ADDENDUM NO. 3
Water Treatment Plant GAC Facility
City of Cynthiana
Cynthiana, Kentucky

**RFI'S FROM CONTRACTORS
ADDENDUM NO. 3**

**WATER TREATMENT PLANT GAC FACILITY
City of Cynthiana
Cynthiana, Kentucky**

GAC BUILDING
PLAN

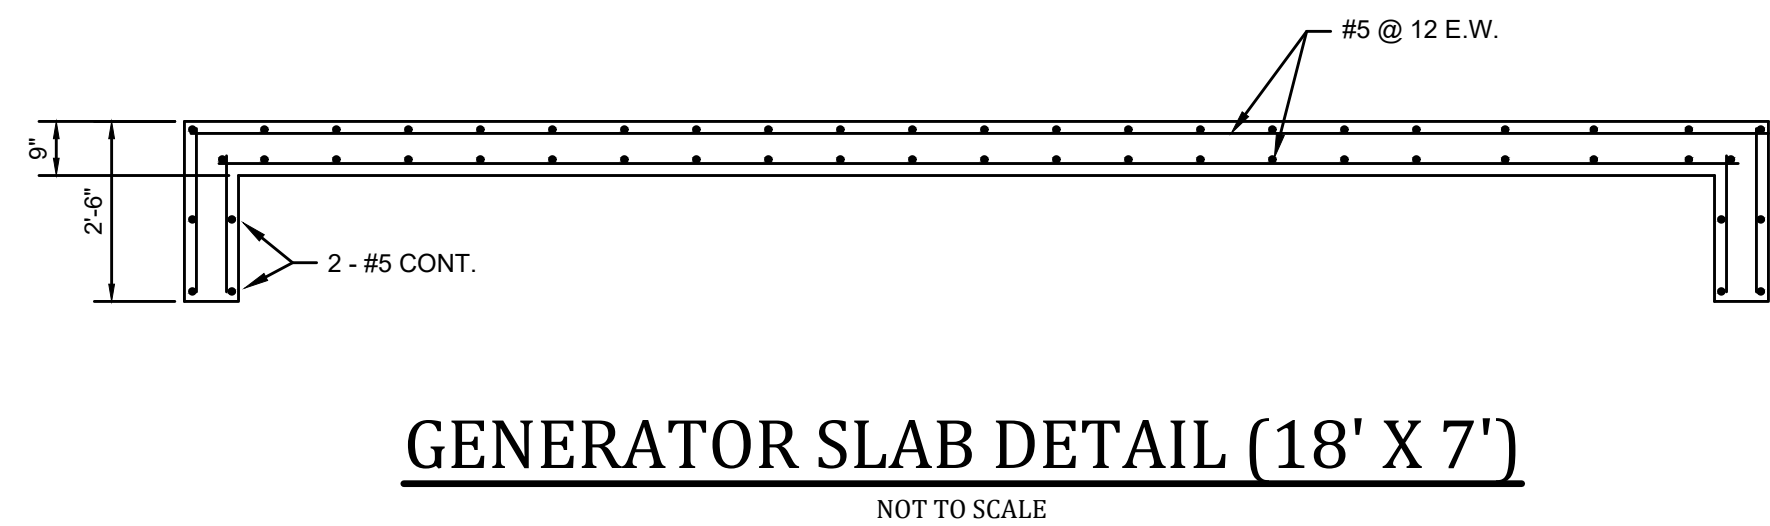
2. *On Sheet C-1-1, Reference Note 6 calls for an "18" Butterfly Valve" to be installed in the unidentified room. On Sheet C-1-4, Reference Note 2 calls for an "18" Butterfly Valve w/Electric Modulating Operator" for the same valve identified above. Please confirm the correct operator for the valve at this location.*

6. *Reference Note 27 on Sheet C-1-1, and Reference Note 17 on Sheet C-1-3 both pertain to "Air Release Valve (Plumb to GAC Wet Well)". Please confirm the correct size of the Air Release Valve.*

7. *On Sheet C-1-1. Reference Note 35 pertains to the "GAC Carbon Fill Discharge Connections – 4" Quick Connect (Typ.) See Detail". Please provide the applicable Detail.*

8. *On Sheet C-1-1, Reference Note 38, and on Sheet C-1-2, Reference Note 14, pertain to "Combination Air / Vacuum Valve". Please confirm the correct size of the Combination Air / Vacuum Valve.*

10. *Information on Sheet I-4 indicates sample lines are to be copper. On Sheet C-1-1, Reference Note 31 calls for "1" PVC Sample Line (Typ.)". Please confirm sample lines are to be PVC.*

14. *Referencing Sheet C-1-1, the 18" GAC influent and effluent DI pipes are shown to be at centerline elevations 703.00 and 704.00, respectively, when tying into the new construction, however, at the tie-in locations to existing 20" FW piping, no inverts or centerlines are provided. Please provide, if available, as-built drawings or approximate existing elevation information for the Existing 20" DI FW lines at the tie in locations.*

RESPONSE: See attached revised plan sheet C-1-1. Reference Note 6 changed to Reference Note 34.

RESPONSE: 2"

RESPONSE: See attached revised sheet SD-2 with Quick Connect detail included

RESPONSE: 2"

RESPONSE: Sample lines shall be PVC

RESPONSE: As-builts indicate centerline elevation of 703.35'. Contractor shall field verify.

SHEET NO.
A-1-04

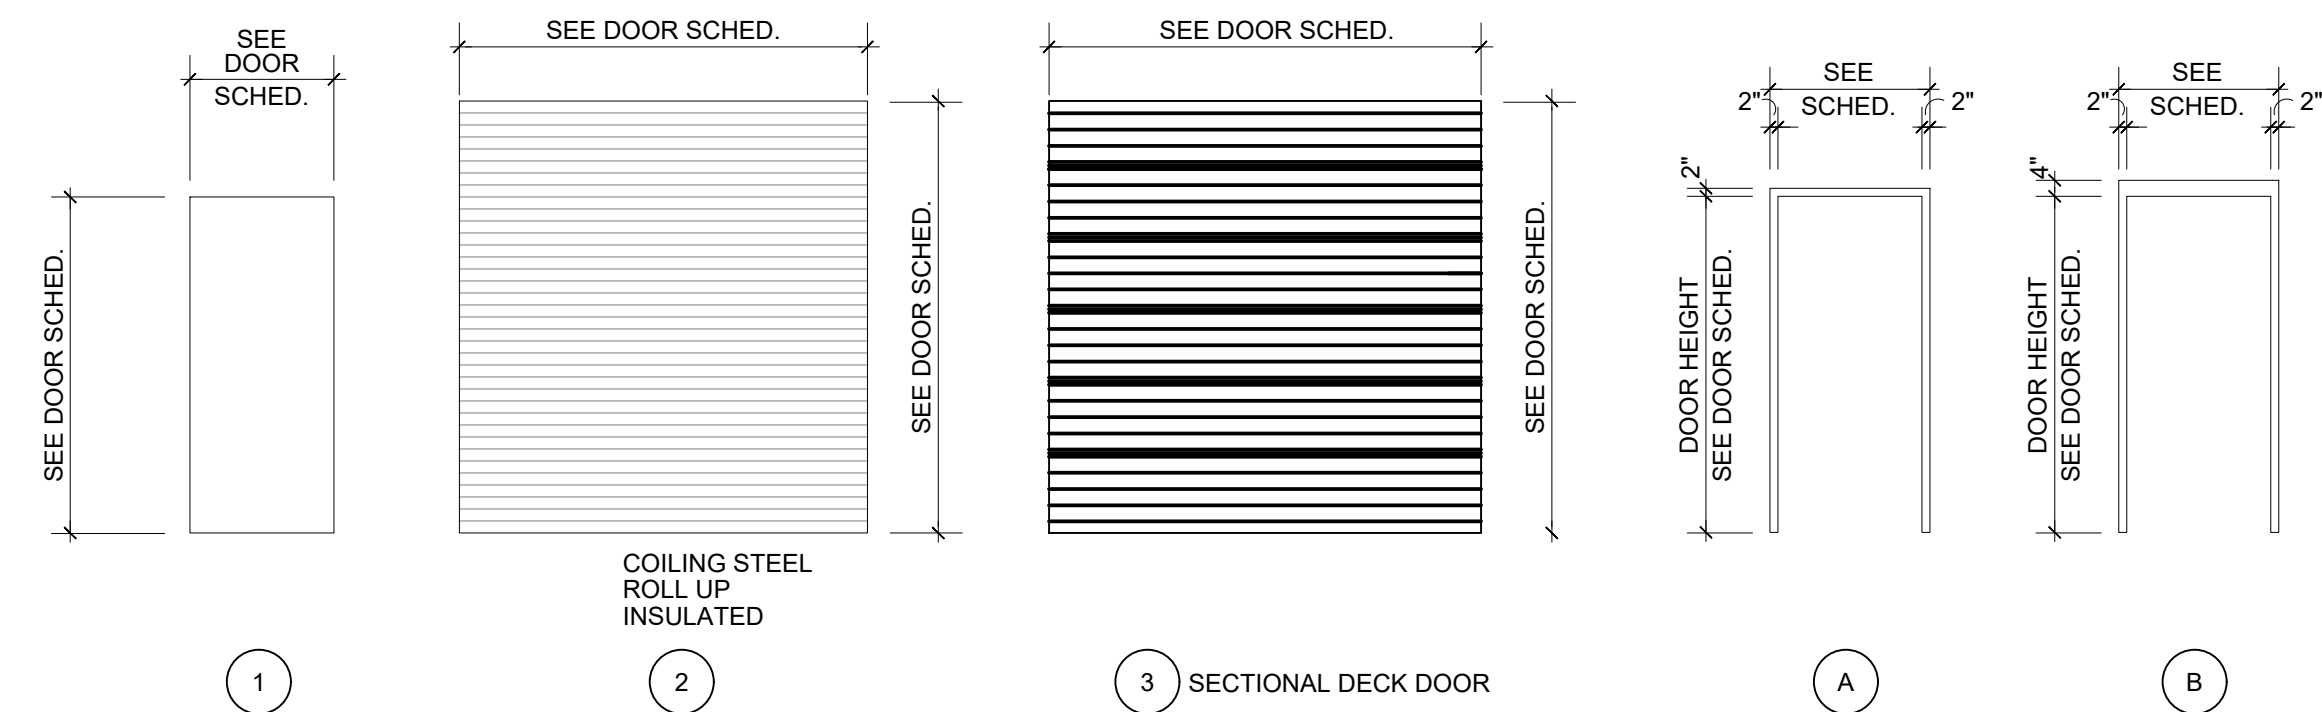
1. *Sheet No. A-1-04 includes a Door Schedule and Door & Frame Elevations, but we find no details pertaining to the intended door hardware. Please provide applicable information for the door hardware.*

RESPONSE: See attached revised sheet A-1-04 which includes a revised door schedule including hardware sets.
